In the Matter of )  
 )  
Advanced Television Systems )  
And Their Impact Upon The Existing ) MB Docket No. 87-268  
Television Broadcast Service )

**LIMITED OPPOSITION TO PETITION FOR RECONSIDERATION AND  
SUPPLEMENT BY GANNETT CO., INC.**

**ENGINEERING EXHIBIT IN SUPPORT OF COMMENTS ON SUPPLIMENT TO A  
PETITION FOR RECONSIDERATION BY GANNETT INCORPORATED**

**ENGINEERING STATEMENT**

### WUSA ANTENNA PATTERN COMPARISON

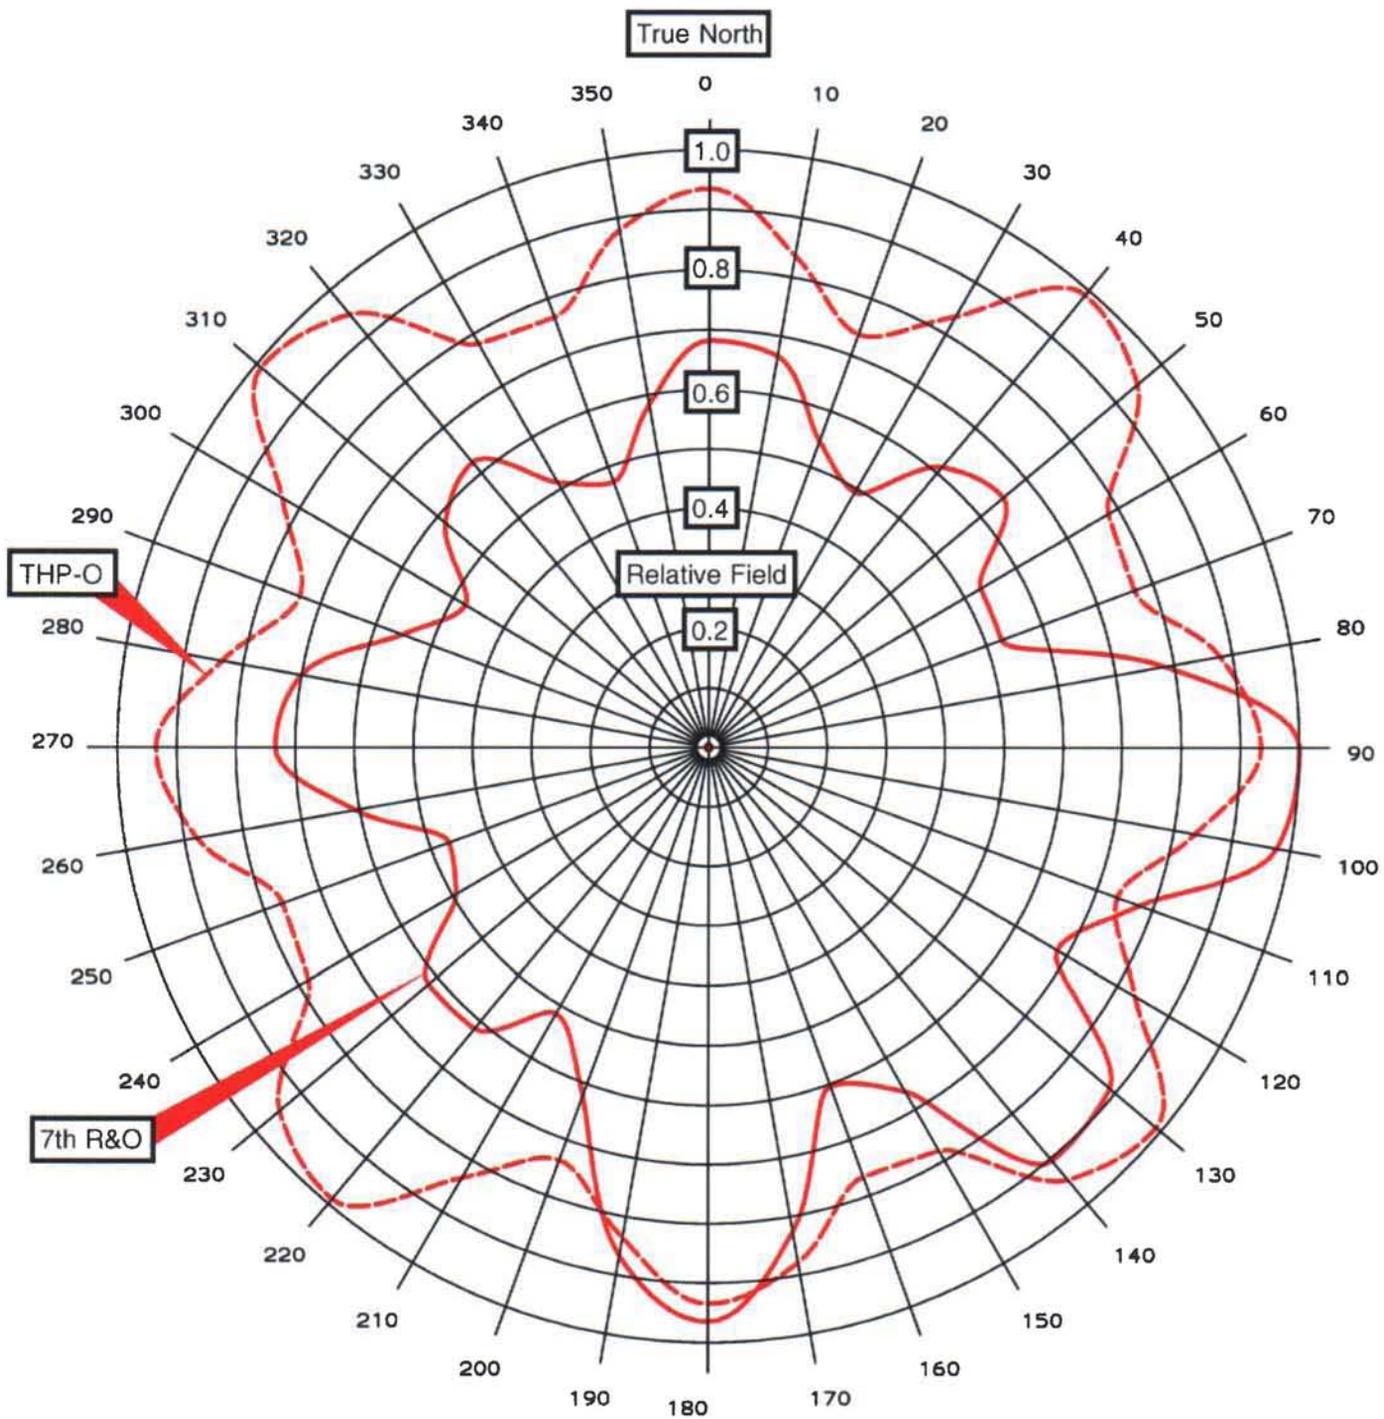
provided on Page 6 of the original petition and attached hereto for reference. It was common practice in the NTSC era to routinely call many somewhat directional practical patterns omnidirectional and specify the gain as simply the root mean square or RMS value of the actual antenna azimuth pattern values. Using this convention results in a transmitted ERP at some azimuths being greater than the RMS value while the ERP at other azimuths is actually less than the RMS value. Figure 1 attached hereto shows the stock actual pattern of the Dielectric “deltawing®” antenna<sup>2</sup> without regard to a specific channel<sup>3</sup>. During the DTV proceeding, the staff has continually utilized antenna azimuth field patterns for every degree<sup>4</sup> and detailed out to the 3<sup>rd</sup> decimal place and has always relied on this level of computational accuracy to determine both coverage and interference populations. SFTI is concerned that since Gannett is proposing to use the already existing Dielectric antenna with the obviously non uniform azimuth pattern, that the 8.7 kW proposed would be set utilizing the measured RMS field thus causing the ERP in some of the azimuths toward WBPH-DT (and possibly other stations) to be greater by upwards of 130 percent thus resulting in an actual calculated interference to WBPH-DT in excess of the 5,587 persons outlined in the Engineering Statement at Table III<sup>5</sup>.

Accordingly, SFTI believes that over the pertinent arcs towards the WBPH-DT coverage area, the actual allowable ERP should not be permitted to exceed 8.7 kW at any azimuth. Based on the detailed cell data from the Longley-Rice study performed for SFTI by MSW, the included angles range from 21 through 55 degrees true rounded to the nearest degree and referenced from the WUSA-DT transmitter site.

<sup>3</sup> The pattern provided by the Joint Petitioners shows amplitude variations somewhat in excess of those of the standard pattern.

<sup>5</sup> The published Dielectric Pattern shows an RMS power gain of 1.30, which results in an RMS field of approximately 0.87. The WUSA-DT pattern supplied by Gannett shows a somewhat greater variation in peak-to-peak divergence from the RMS and possibly a slight variation from the standard RMS. Based on the supplied plot, the existing WUSA azimuth pattern exceeds the standard RMS value from approximately 33 through 54 degrees.

In summary SFTI will accept proposed modified facilities that, using actual measured, WUSA azimuth pattern data, result in the WUSA-DT9 ERP not exceeding 8.7 kW with an HAAT of 235 meters over the arc from 21 through 55 degrees as referenced from the WUSA-DT transmitter site. This limitation will therefore be expected result in a calculated increase in interference to WBPH-DT to comply with the FCC 0.1% standard.
